Town of Whitby Staff Report

Report Title: **DEV-23-21: Draft Plan of Subdivision Application SW-2021-07, Zoning By-law Amendment Application Z-13-21, Winash Developments Limited (Phase 2), 145 Winchester Road West**

Date of meeting: March 28, 2022

Report Number: **PDP 20-22**

[Attachment #3: Proponent's Proposed Draft Plan of Subdivision](#)

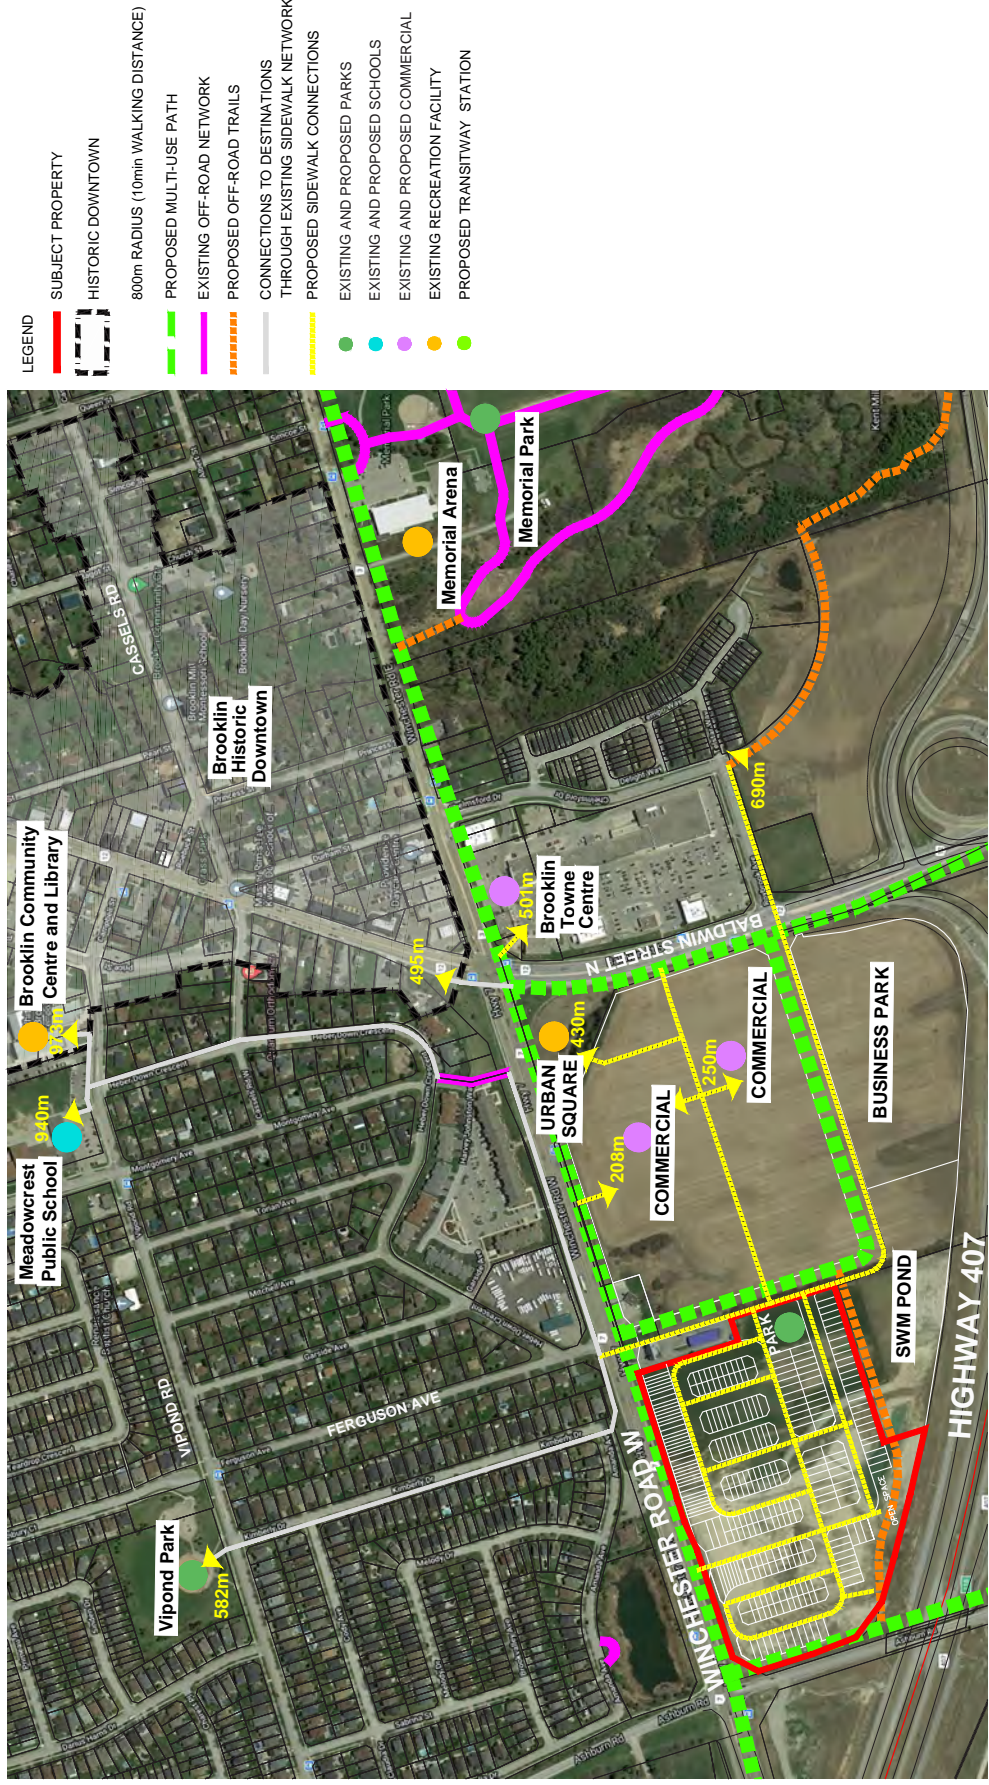
1.1 Revise the Draft Plan (DP) as follows:

- a. Clarify the function and confirm proposed ownership of Stormwater Management (SWM) Block 41. This block appears to contain 2:1 sloping and should be revised to a 3:1 slope and labeled as a grading block or included as part of the adjacent right-of-way.

- 2.17. Driveway access to the units on Block 1 shall only be permitted on to Street B.
- 2.18. The Subdivider shall provide preliminary driveway alignment plan Blocks 1, 2 and 6, to confirm that there is sufficient frontage to accommodate the driveways without conflict.
